Product change notification (PCN)

Title / short description	Update of approvals for the PLC-INTERFACE product portfolio for use in potentially explosive atmospheres
Affected article category	Relay modules
Change category	Marking, Approval
Change number	CDK250063-00
Reason for PCN/PDN Revision

Update of approvals for the PLC product portfolio for use in potentially explosive atmospheres

CDK250063

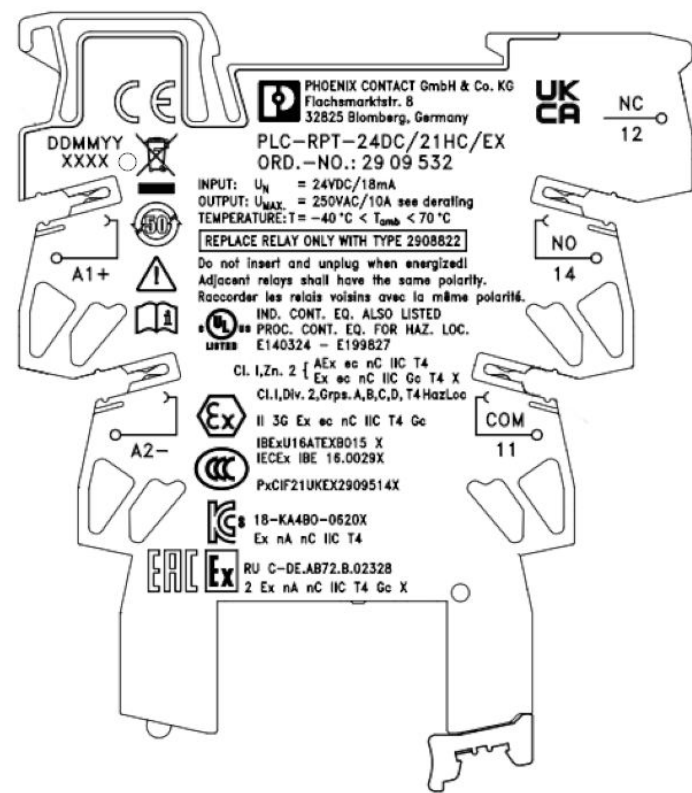
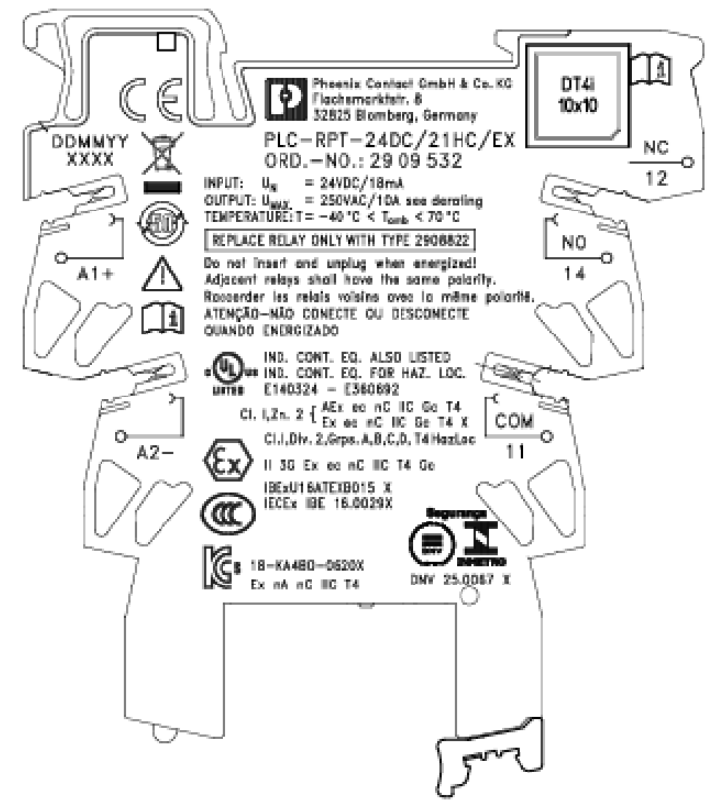
The approval status of the PLC - INTERFACE product portfolio for use in potentially explosive atmospheres has been revised (see list). As part of the update, the EAC approval will be removed, and the UKCA logo will no longer be printed on the products. In addition, a new certification according to the Brazilian InMetro standard has been obtained.

Due to the update of the UL HazLoc approval, a new standard now applies. UL 60947, instead of the previous UL 61010.

The previous marking text:

"Industrial Control Equipment

ALSO LISTED Process Control Equipment for Hazardous Locations

E140324 E199827"

will change to:

"Industrial Control Equipment

ALSO LISTED Industrial Control Equipment for Hazardous Locations

E140324 E360692".

This results in a change of the certificate number (E File). These changes require updates to the product marking, the printed information in the packaging leaflet, and the certificates provided in the e shop. A comparison of the new and current product marking is provided in the attachment.
